In the Drawings:

YOR9-2000-0402 US1 (RPT) (8728-497)

— Prior Art—

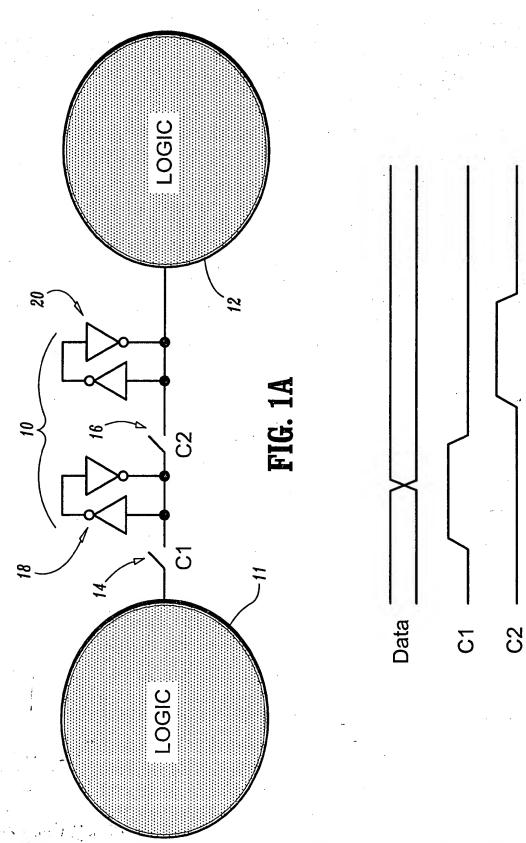
Figures 1A, 1B, 2A, and 2B have been amended to include the legend "--Prior Art--" as represented in the Replacement Sheets for Figures 1A, 1B, 2A, and 2B, attached to end of this document.

6/12 YOR9-2000-0402 US1 (8728-497)

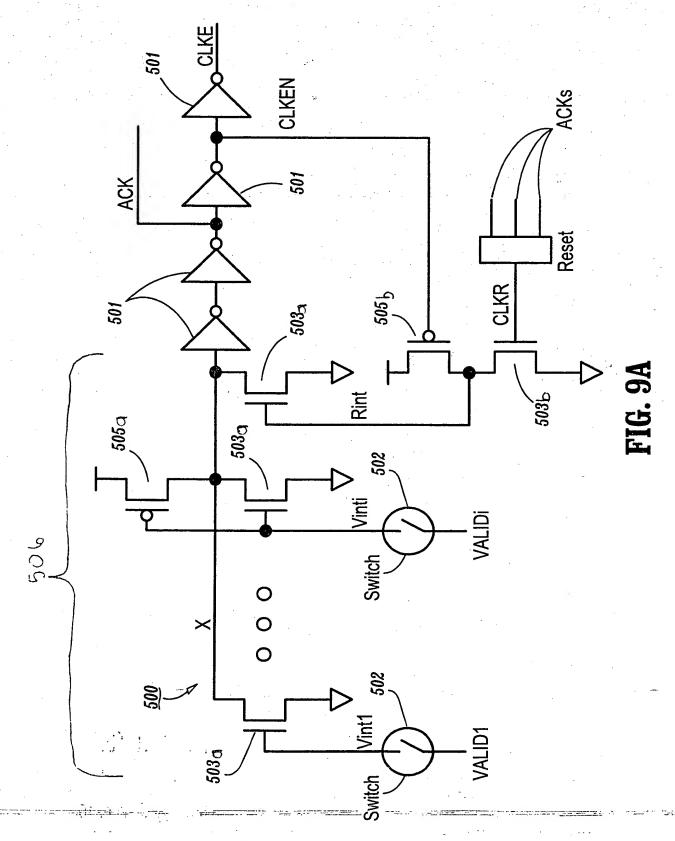
In the original Figure 6 the reference character "306" had been used to designate "Logic i", "Logic j", and "Logic k". As represented in the Replacement Sheet for Figure 6, attached to the end of this document, reference character "306a" is now used to designate "Logic i". The reference character "306b" is now used to designate "Logic j". The reference character "306c" is now used to designate "Logic k".
